Code Compliance Certificate

Building Work: Install pellet burner onto existing hearth and install flue through existing chimney

Consent No: **210074**
Applicant: **Anne Maree Paora**
Valuation Ref: **29860/198.00**
Site Address: **40 River Street MATAURA**
Work Type: **Install pellet burner onto existing hearth and install flue through existing chimney**
Email To: **hotspotinstalls@gmail.com,davidpaora@rocketmail.com**

Hybrid Flue Kit

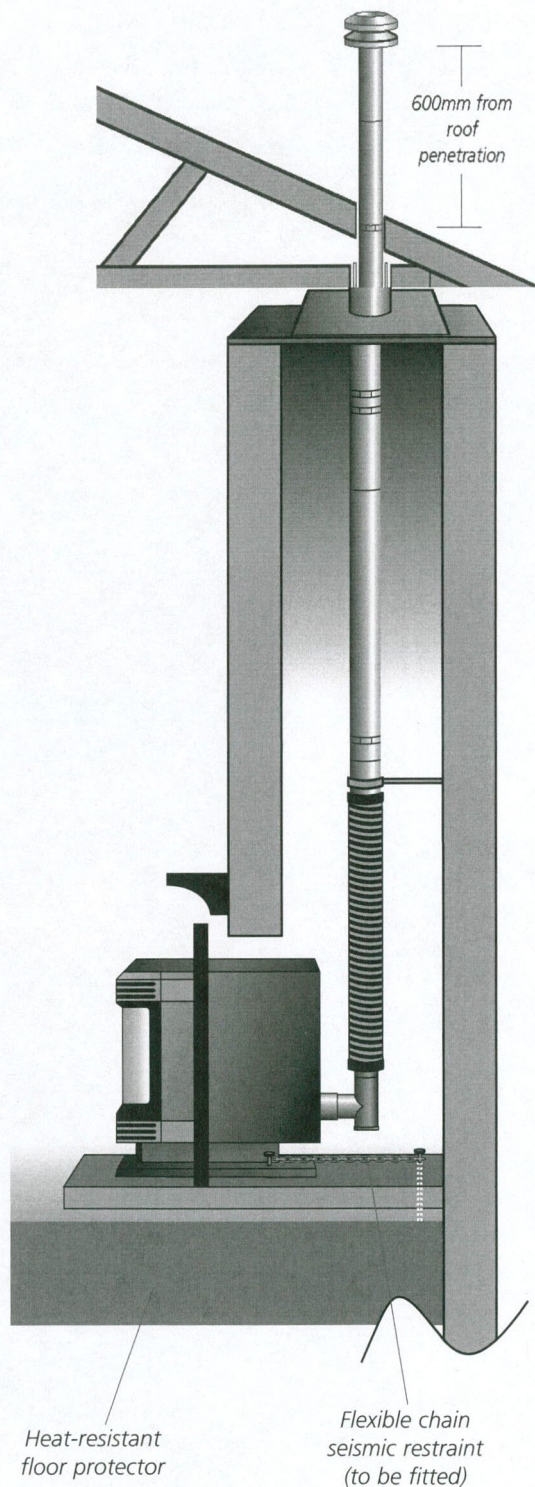
- 27/8/20 RFI Notes brief
Ravelli Rosa R70 Treestanding (wood pellet heater)
- 1 Hand drawn details differ from Davia manufactures flue kit spec supplied with application

*Hybrid
+ Flue detail
Email
received
21/9/2020
with reference
to correspondence
between installer
& manufacturer
17/9/2020*

SUPERCEDED

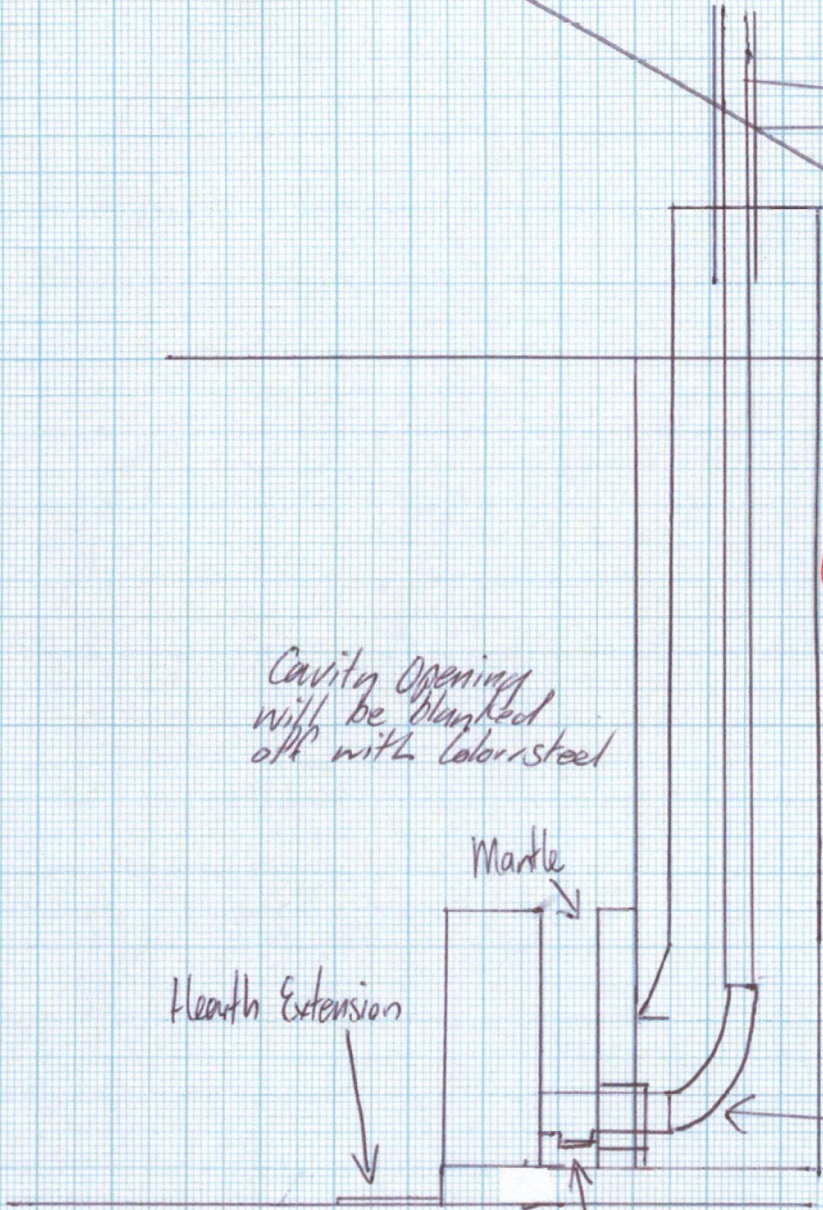
1. The reply to question 1 has not been fully answered and accepted. The revised hand drawn detail supplied on the 8 September 2020 – 10.58am of the heater install appears not to match the Davin (52) Insert flue kit specification supplied in the application.
 - Please have the manufacturer confirm the structural stability of the chimney and which construction detail they are covering in their email.
2. Please have the manufacturer confirm with details if the existing chimney is required to be vented as per AS/NZS 2918:2001 item 3.4.
3. No information has been supplied in answer to question 4 of the RFI dated 27 August 2020, haven't yet been answered. Please provide.
4. No information has been supplied in answer to question 7 of the RFI dated 27 August 2020, haven't yet been answered. Please provide.

1. The hand drawn detail supplied on the 24 August 2020 of the heater install appears not to match the Davin (52) Insert flue kit specification supplied in the application.
2. Please provide manufacturers written confirmation that this hand drawn detail is acceptable.
3. How is the existing masonry chimney sealed/capped at the top within the ceiling space? To prevent heat/flumes entering into the roof space.
4. If the existing chimney is sealed/capped, is there a likelihood of any heat being trapped at the top of the sealed/capped chimney due to the liner extending into the chimney.
- ✓ 5. Is the cone/cowl vented for the 100mm liner?
6. How is the 100mm liner going to be supported?
7. Provide the manufacturers detail of the 150mm dia wall thimble you are proposing to use.

Cavity Opening
will be blanked
off with Colortsteel
